Response to Anonymous Referee #2's comments on manuscript hess-2022-87

In this document, authors respond to comments from Referee 2 (response to referee 1 and community comment added as additional information at the end of the document for reference) regarding the manuscript titled, "Poor correlation between large-scale environmental flow violations and freshwater biodiversity: implications for water resource management and the water planetary boundary."

Fig. 5 Coefficient of correlation (r^2) for multivariate regression. Each row represents on biodiversity indicator and each column represents one G200 ecoregion

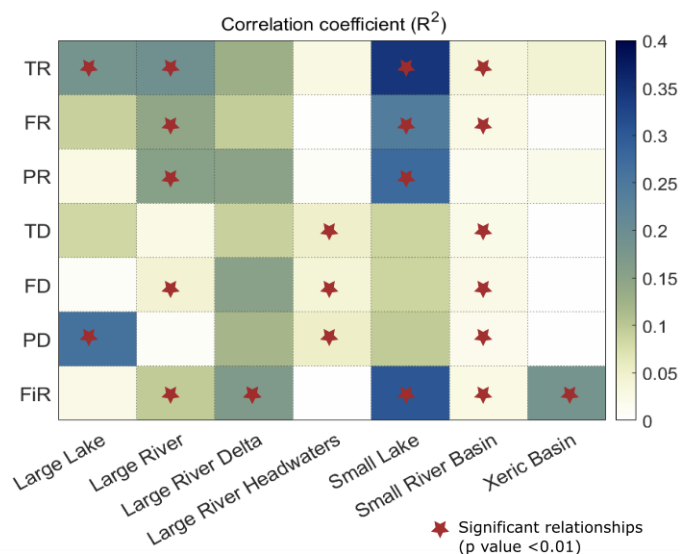
Comment 2.2: A second comment is on the use of correlation only. Why look at this on a one vs. one variable basis? Why not develop appropriate statistical approaches to look into the effects of the explanatory variables at the same time. which can also provide statistical significance?

Response 2.2: Considering the suggestion from the Referee 2, a multivariate regression analysis was carried out for each G200 ecoregion when revising the paper. These new results were added in the manuscript (See section 3.2, Fig. 5). The results are in line with the single variable linear regression analysis given in the main manuscript. The mean coefficient of determination (r^2) is approximately 0.1.

Line 380-384: In addition to this, the multivariate regression analysis results (Fig. 5) also show very low correlation between EF violation indicators and biodiversity indices in most G200 ecoregion, except in small lakes where the coefficient of determination is between 0.25 - 0.4 for the richness indicators (TR, FR, PR). The mean coefficient of determination (r^2) is approximately 0.1.

Fig. 1 Methodology outline for (a,b) EF violation indicators calculation and (c)EF-biodiversity relationship evaluation

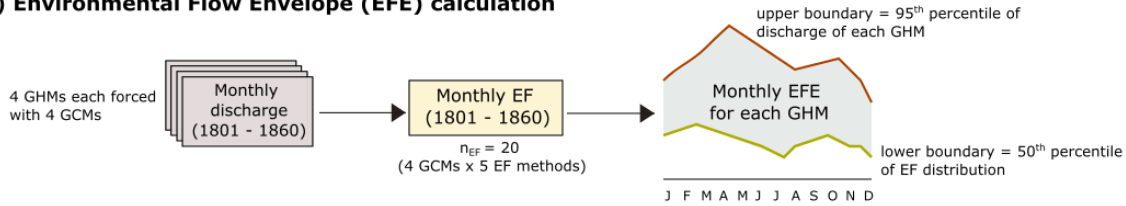
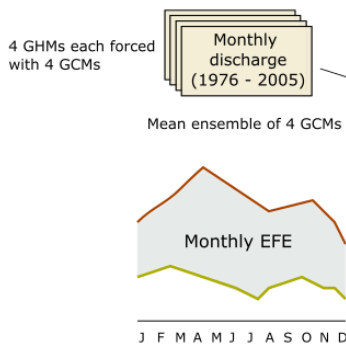
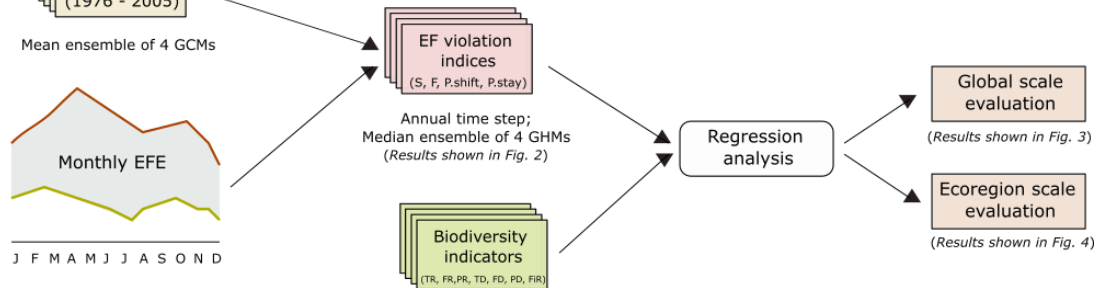
Comment 2.4: Data: While Table 1 provides a nice summary of the various data in this study, a flowchart diagram is strongly recommended to help readers to understand the different underlying layers, e.g., the different variables, the different EF calculation methods, the different GCM models, etc.

Response 2.4: A flowchart summarizing the EF violation indicators calculation is added (see new Fig. 1)

Fig. S12 EF violation indicators' coefficient of variance within fish facets data catchment boundary (Su et al., 2021): EF violation (a) frequency and (b) severity

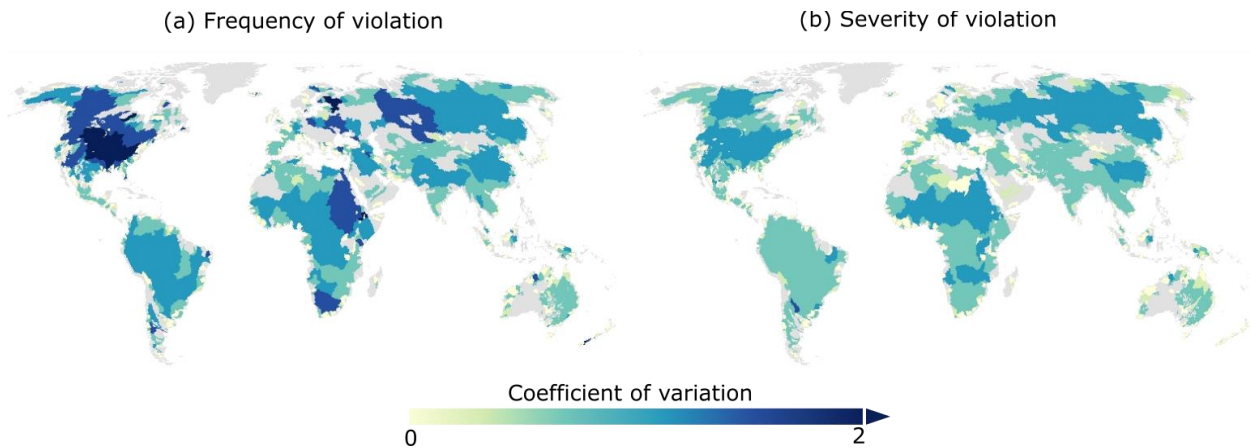
Comment 1.1: EF violation does not explain changes in biodiversity at the scales of consideration. It would seem that the authors have the tools and the datasets to address some of the major challenges they discuss. In particular, the authors recognize scale and scale matching as issues, and even discuss a solution for dealing with it (Line 266).

Additionally, as suggested by the Referee, when revising the manuscript we estimated the variance of EF violation indicators within the catchment boundary (consistent with Su et al.'s facets). The results were added in the Supplementary material (See section S10, Fig. S12 in Supplementary Information).
